From: Michelle Good
Sent: 13 October 2016 16:58
To: Heather Lealan
Cc: Jamie Gargett
Subject: FW: Hayling Billy Pub, Elm Grove, Hayling Island - updated Arb submission

Having reviewed the updated Tree Protection Plan (9030/02 Revision C), I note the provision for a new service corridor remote from root protection areas and the identified extents of 'no dig construction' for proposed paving within root protection areas.

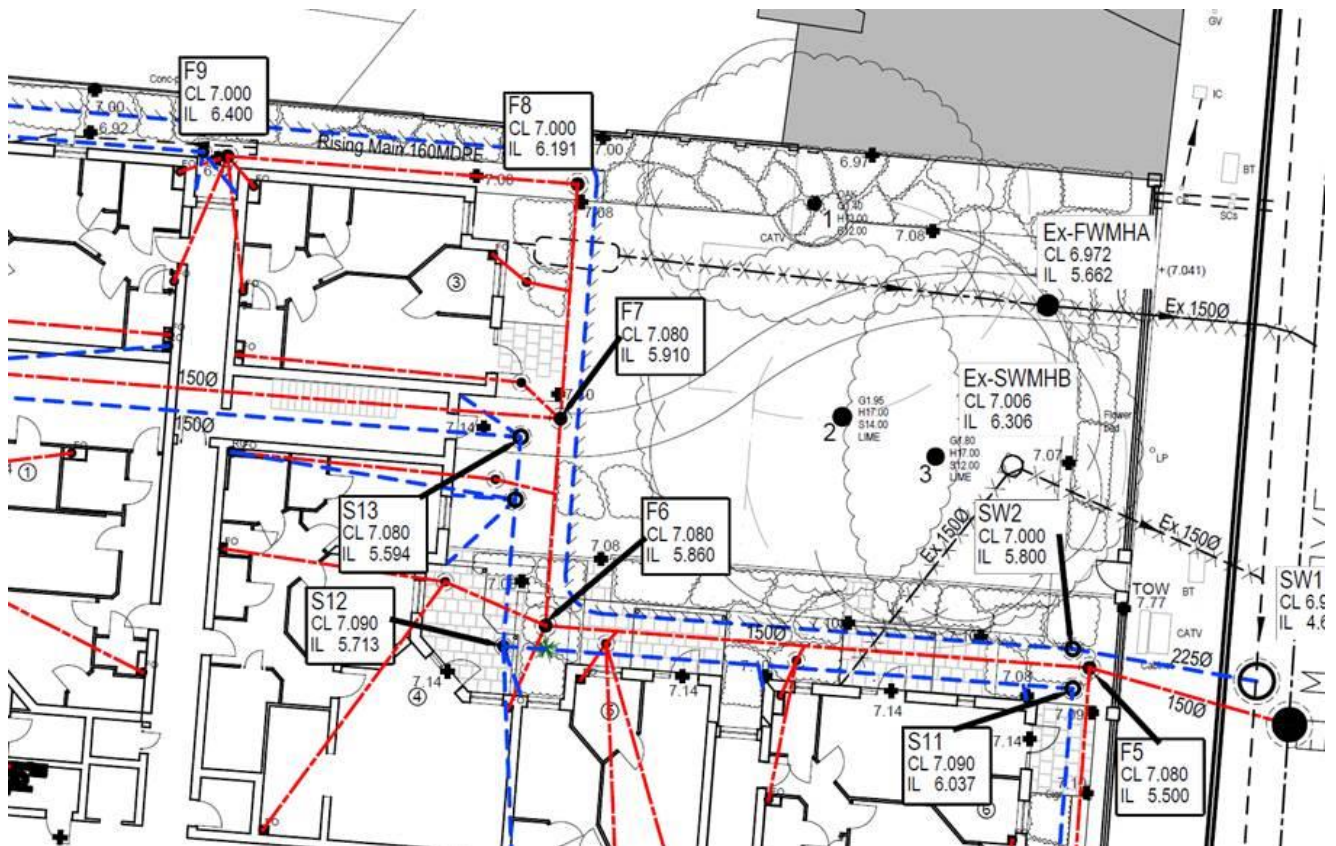
I remain concerned that conflicts between proposed drainage runs and tree protection areas have not been resolved by the updated Tree Protection Plan or the Method Statement.

The first extract below shows surface water and foul water drainage runs within the root protection area of T2 and T3.

The second extract below shows surface water drainage (including a manhole) within the root protection area of T7 and T8.
